ARLINGTON AVENUE BRIDGES REPLACEMENT

Design Review Committee Meeting #7 | November 8, 2022

Purpose of Today's DRC Meeting:

Island Avenue Storm Drain Xing into Truckee River

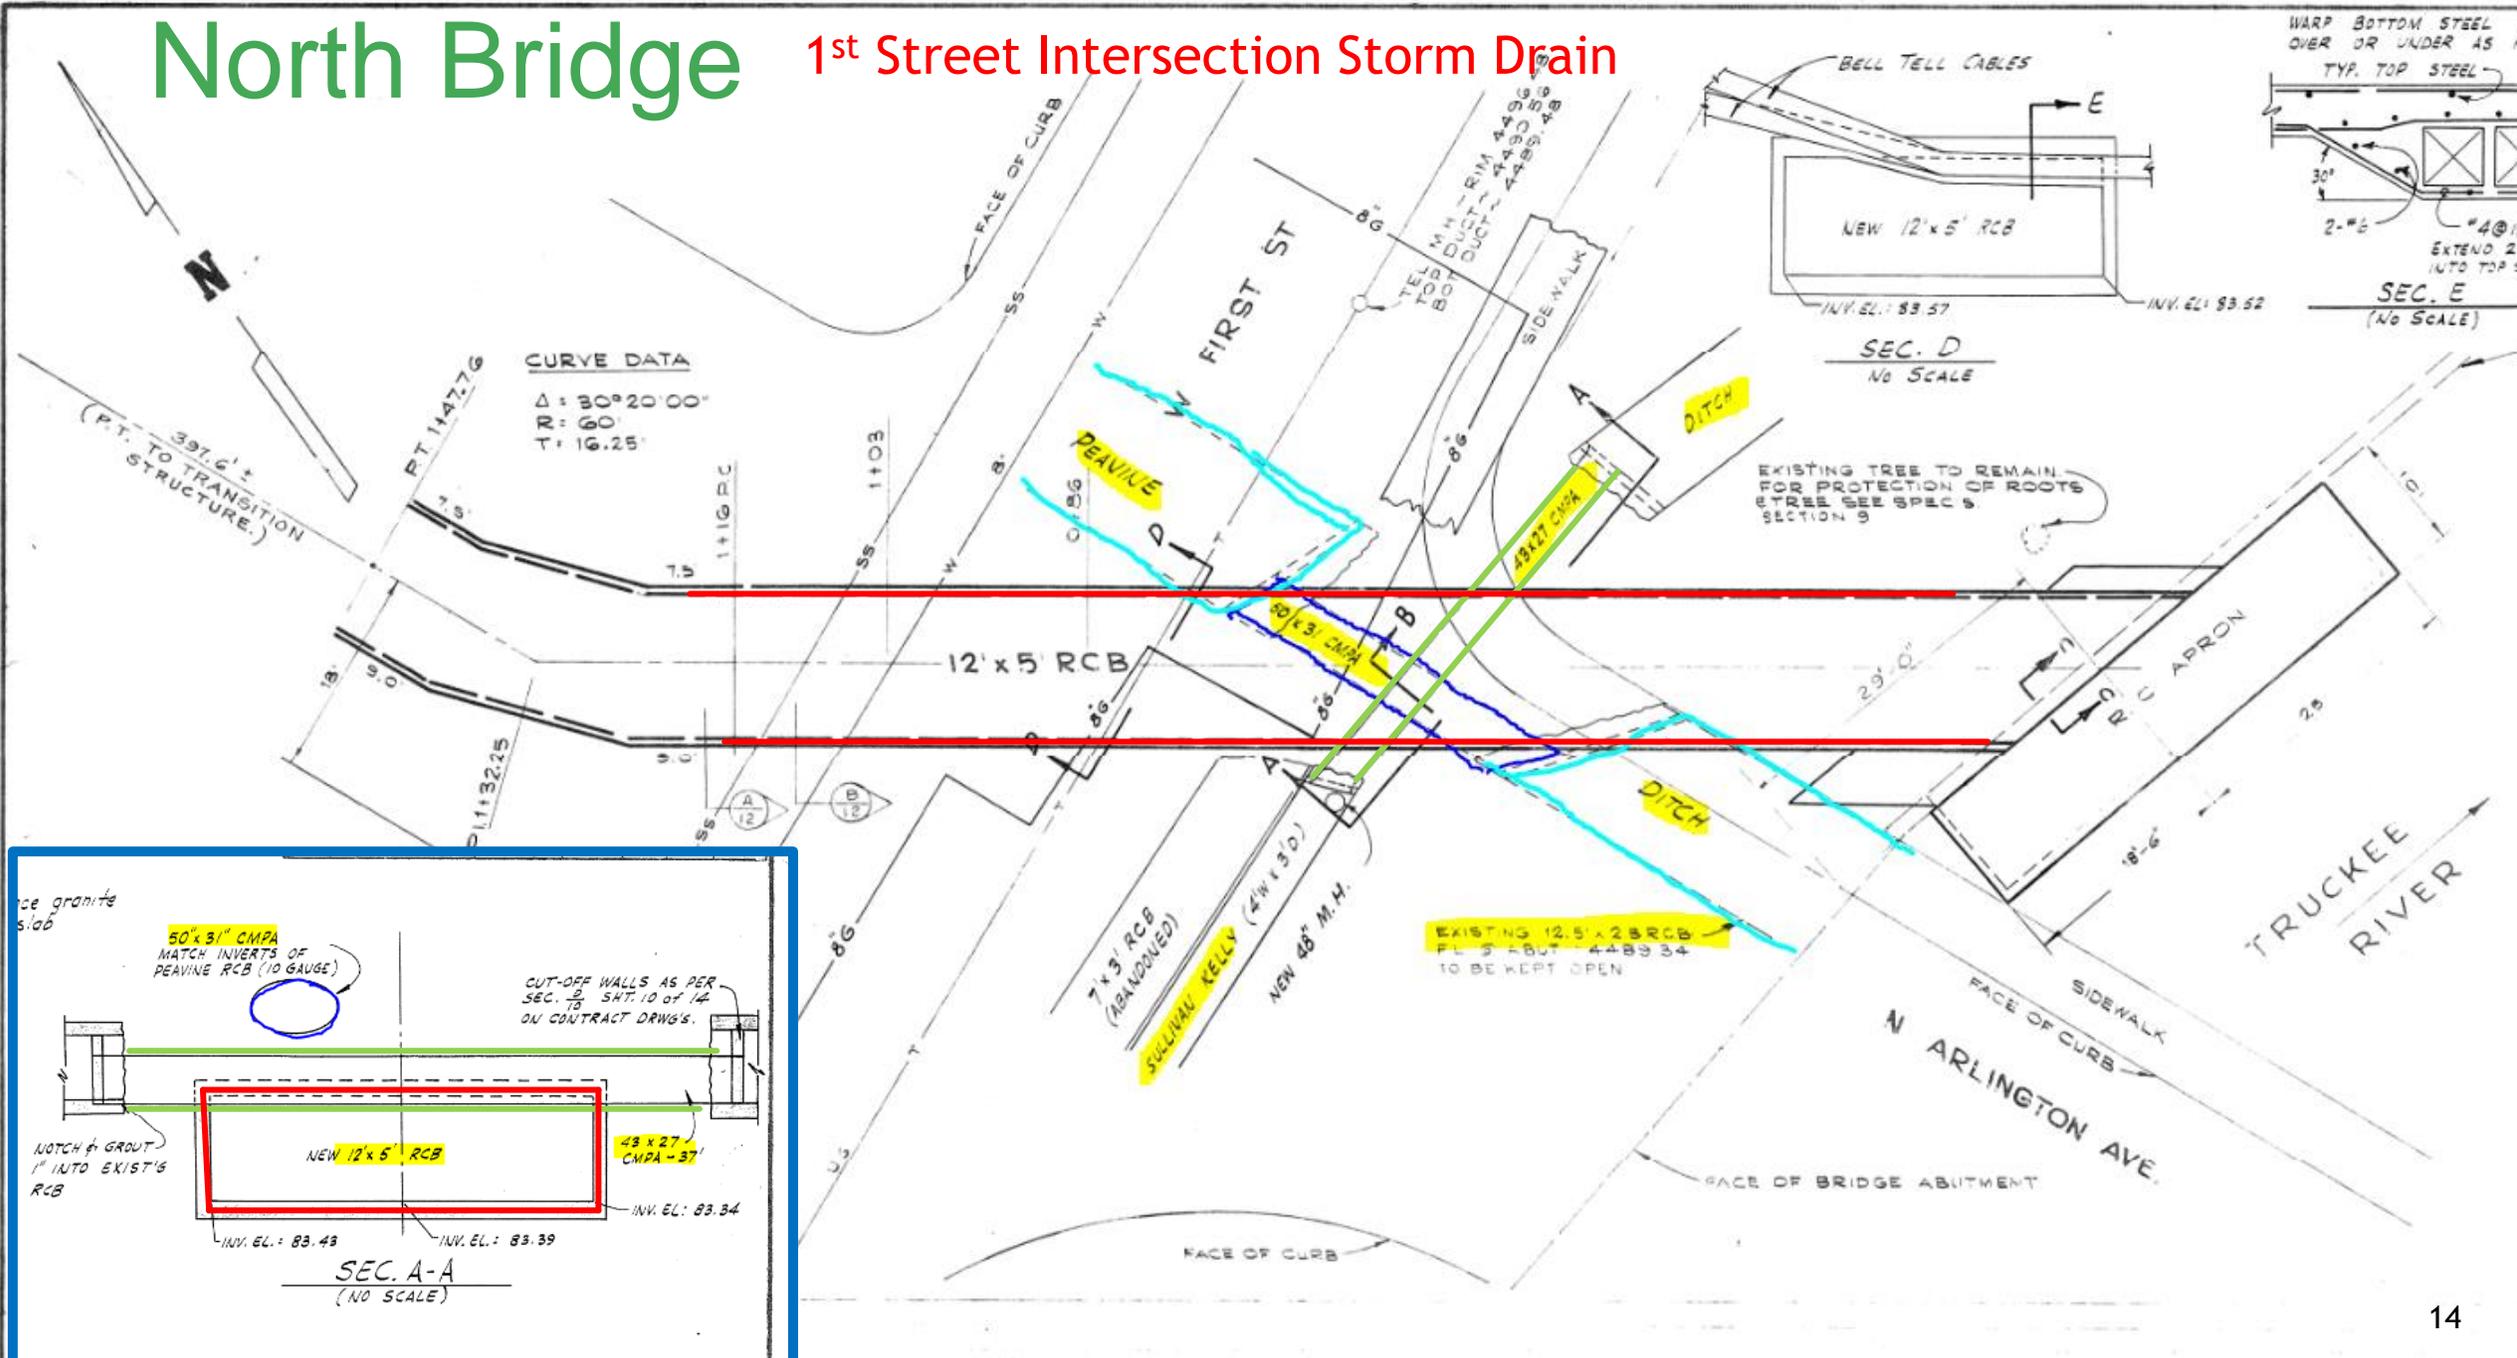
Confirm SD Size - 42" or 36"

Park Irrigation

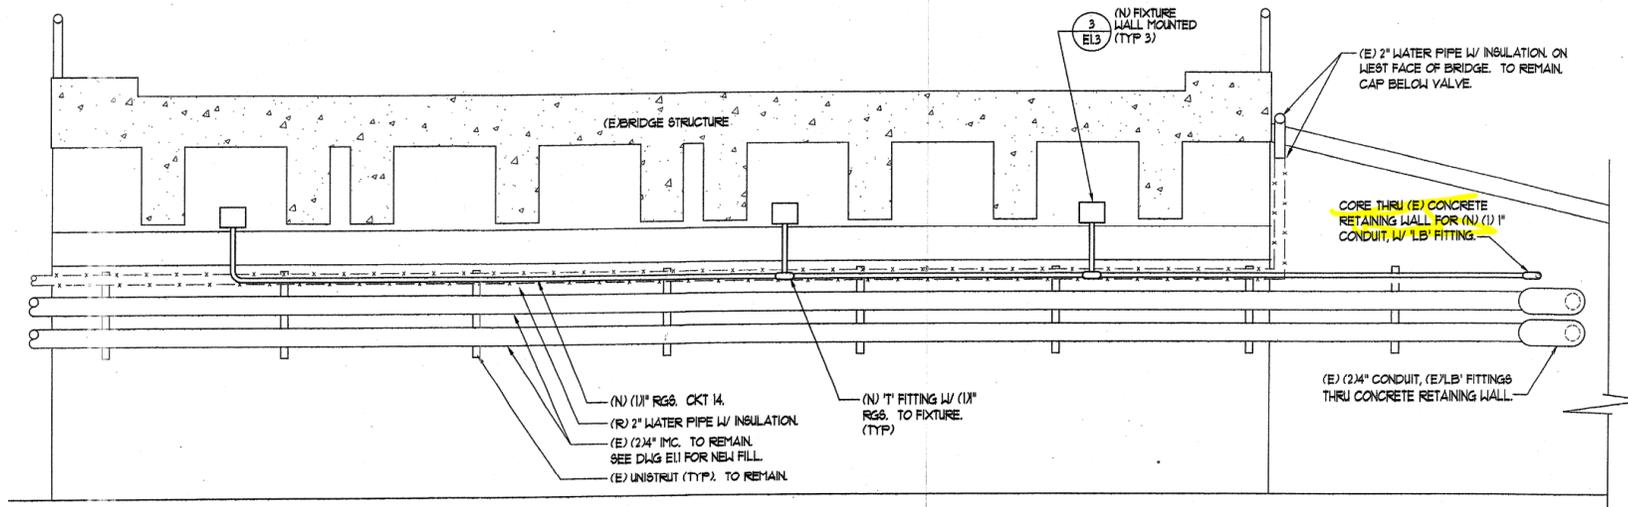
- Across West Face of Bridge - 2 Pipes
- Assume 1 for H₂O and 1 electric for sprinkler system?

Conduit Along Path

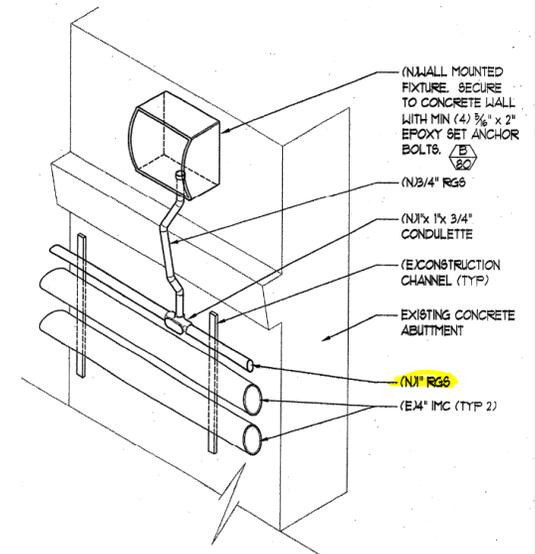
- 1 - 1" Electrical Conduit:
Under bridge lighting?
